RE: Town of Hull Well Impact Claims

As per your request, I have reviewed the claims of impacts to private wells from the operation of City of Stevens Point Well 11 as described in a report from Montgomery Associates Resource Solutions (MARS) prepared for the Town of Hull dated October 9, 2014.

Figure 3: Depth to Water in USGS Monitoring wells and MW3

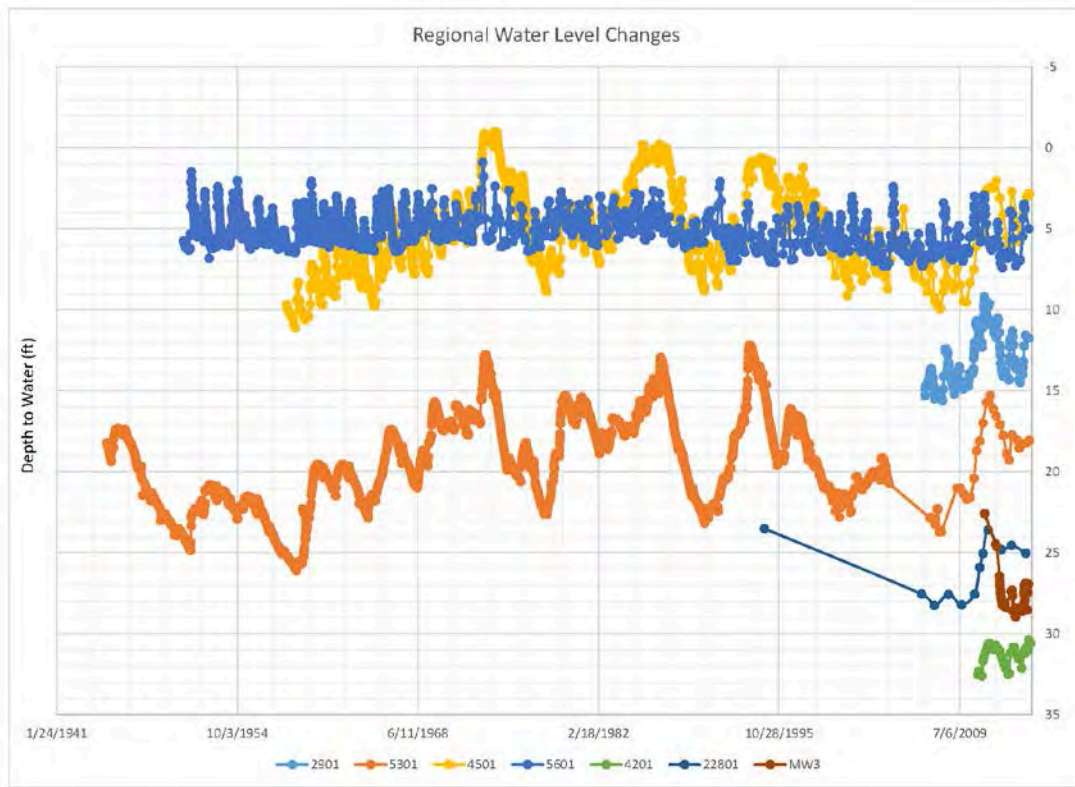
Figure 3 is a plot of the depth to water for the seven USGS monitoring wells and City monitoring well MW3 for the period of record. The USGS wells lie about 7 to 15 miles from Well 11 and are located in areas with land use that ranges from predominantly forest to predominantly irrigated agriculture with some areas of mixed forest and agriculture. The USGS wells provide independent observations of groundwater levels that are miles beyond any potential impacts from Well 11 and reflect regional changes in groundwater storage. The data shows that water levels in the aquifer on a regional basis naturally vary by several feet in response to seasonal and annual changes in recharge and regional pumping.

Figure 4: Plot of Changes in Ground Water Levels for the Last 5 years

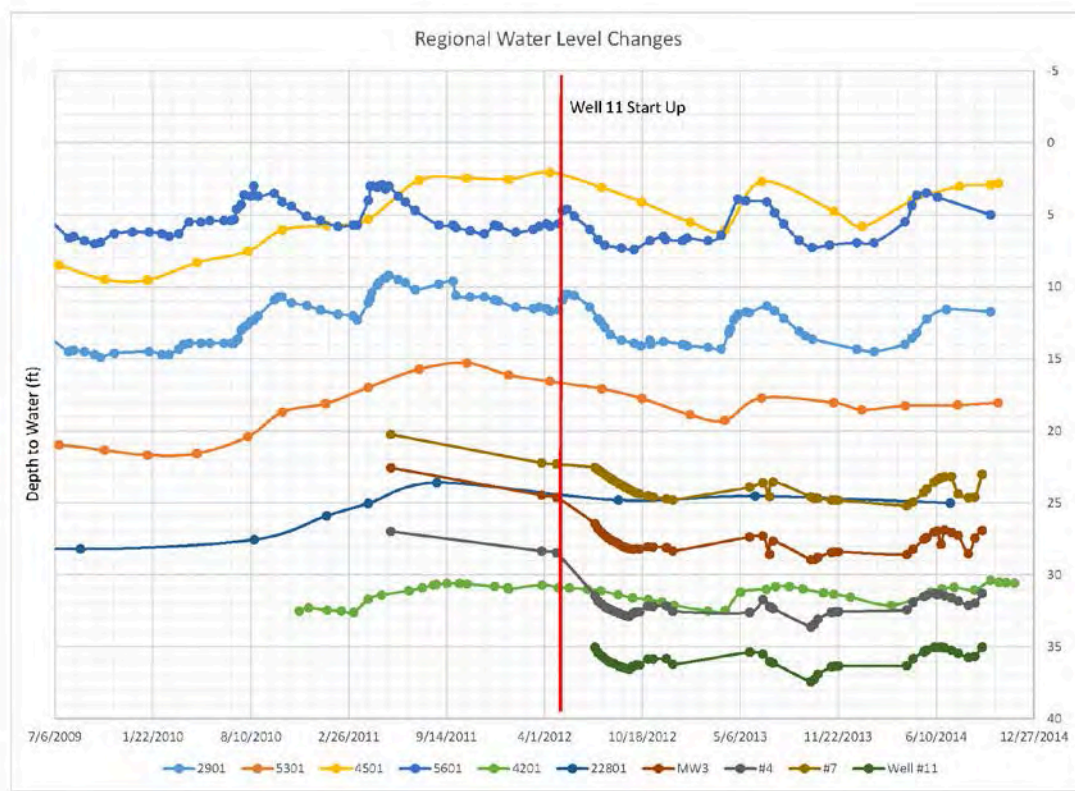
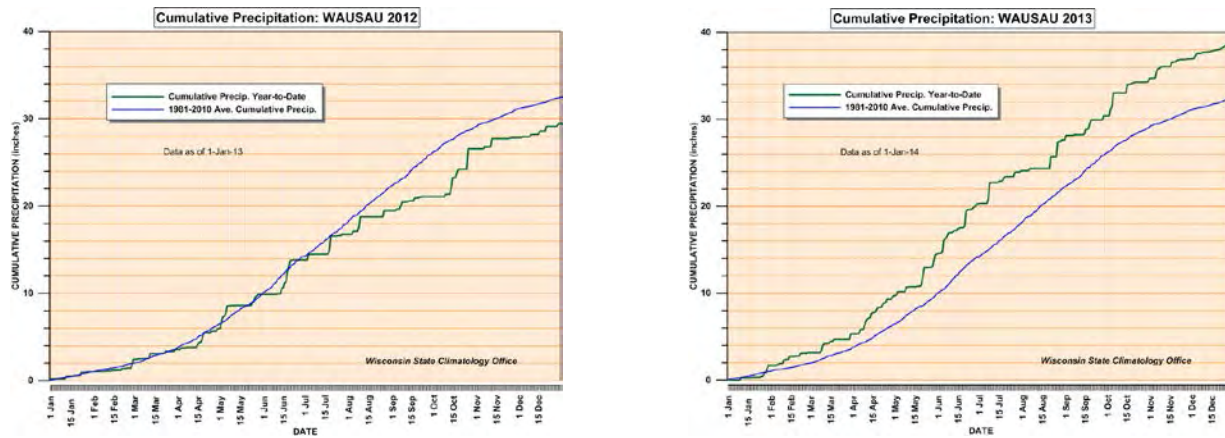
Figure 4 is a plot of the depth to water for the USGS monitoring wells, Well 11, and the three closest City monitoring wells to Well 11 for the last five years. Groundwater levels gradually increased by about three to five feet in all wells from early 2010 through the end of 2012. Water levels in all wells began to decline in the spring of 2012, coincidentally about the time Well 11 began pumping. However, the decline in water levels occurred in all wells, even though the USGS wells are well beyond the limits of any potential pumping effects of Well 11. The data shows the decline in water levels was regional in nature and was not specific to the area around Well 11.

Groundwater levels generally declined throughout 2012 and recovered quickly in the spring of 2013. The decline in groundwater levels seen in the City monitoring wells near Well 11 looks very similar to the declines observed in several USGS monitoring wells including USGS MW2901 and USGS MW5601. USGS MW5301 and USGS MW4501 showed similar magnitudes of variation but the measurement frequency was lower so it is not known if the rate of decline was similar to the City monitoring wells.

USGS MW2901 is approximately 7 miles south of Well 11. USGS MW5601 is approximately 15 miles south of Well 11. Both of these wells are in areas dominated by irrigated agriculture. USGS MW5301 is located approximately 15 miles north of Well 11 in an area dominated by forest land. USGS MW4501 is located approximately ten miles southeast in an area of mixed forest and agriculture. The data suggests that the changes in groundwater levels were regional in extent and were independent of land use suggesting that the cause was a change in recharge rather than an increase in pumping.

Figure 6: Change in Water Level of USGS MW2901 vs. MW3 Since Well 11 Start Up

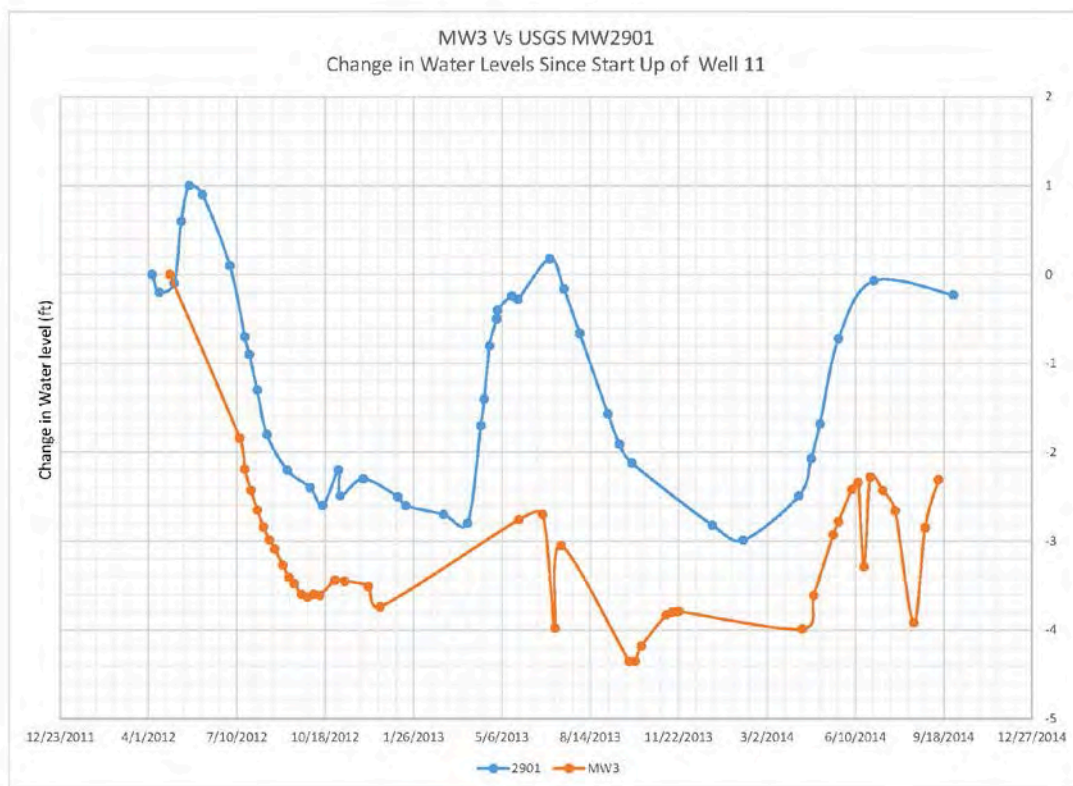
Figure 6 is a plot of the change in groundwater level since the startup of Well 11 for MW3 and the closest USGS monitoring well, USGS MW2901. The plot was calculated by setting the water level in each well from March 2012 to 0 and plotting the rise or decline in subsequent readings.

The maximum change in groundwater levels in MW3 since Well 11 started pumping is about 4 feet. This represents the maximum impact that could be attributed to Well 11 if there were no other factors affecting water levels in the aquifer. However, the regional water level shows that water levels declines of a similar magnitude were occurring throughout the aquifer over an area of miles around the well during the same time period. This indicates that a significant portion of the observed decline in water levels around Well 11 was due to regional factors and the actual impact is significantly less than 4 feet.

The plot also shows that the changes in groundwater levels in the two wells generally track each other from the point of startup of Well 11 with the exception of a downward bias of about one to two feet in MW3. This is direct physical evidence that the groundwater levels around MW3 were one to two feet lower than expected. Most of this difference is probably due to pumping at Well 11. While simplistic, this estimate is based on field data and is more reliable than estimated values. Changes much lower than this magnitude are difficult to detect or accurately measure. Based on the available data, it is my opinion that the drawdown in the aquifer at MW3 caused by Well 11 after pumping 2.8 mgd for over two years was clearly less than 4 feet, most probably less than 2 feet, and could be on the order of one foot. Drawdown from a pumping well declines logarithmically with distance from the well. The magnitude of drawdown from Well 11 would be substantially less beyond MW3 farther from Well 11.

With any of these estimates the change in the saturated thickness of the aquifer at MW3 is on the order of 1% to 5%, and much less in the area of most of the wells in question that are farther from Well 11. The drawdown from Well 11 in the area of concern is much less than the normal range of variation in the aquifer and small enough that it is difficult to measure. It is a small percentage of the available thickness of the aquifer and not enough to limit the ability of a home owner to obtain water from a reasonably well constructed well.
